**SERVICE PLATFORM #19E
 EQUIPMENT ARRANGEMENT PLAN**
 SCALE: 1:40

CONTRACT CHANGE ORDER NO. _____
 SHEET _____ OF _____

DETAILS
BRIDGE STRUCTURES GIRDER EASTBOUND
SKYWAY STRUCTURES-SERVICE PLATFORM #19E
 SCALE AS NOTED

E-832

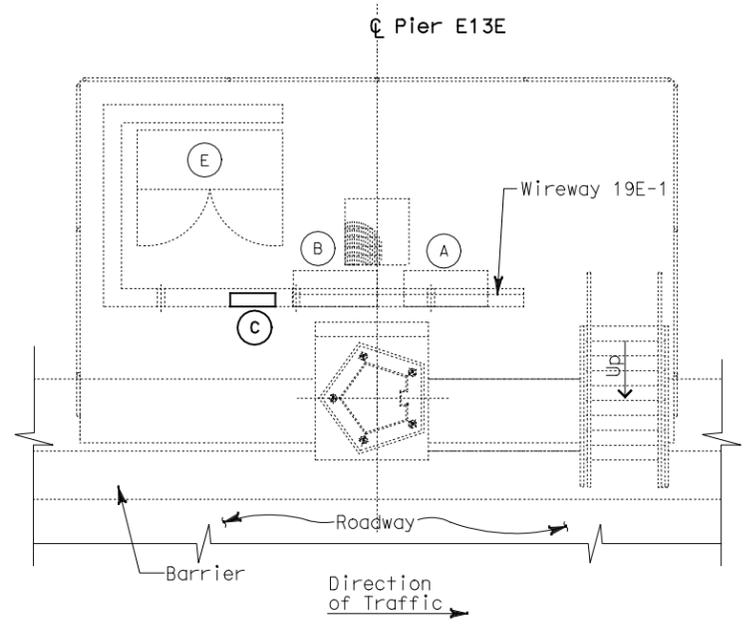
- Terminate already installed 50 pair telephone cable in Telephone Terminal Box. See sheets E-961, E-963 and E-965.
 - Furnish and install the 15kV cables into existing cable tray shown on this drawing. See sheet E-837.

- Furnish and install the TOS fiber optic cables into existing cable tray shown on this drawing. See sheet E-983.
 - Inspect for system ground continuity. See sheets E-839 and E-840.
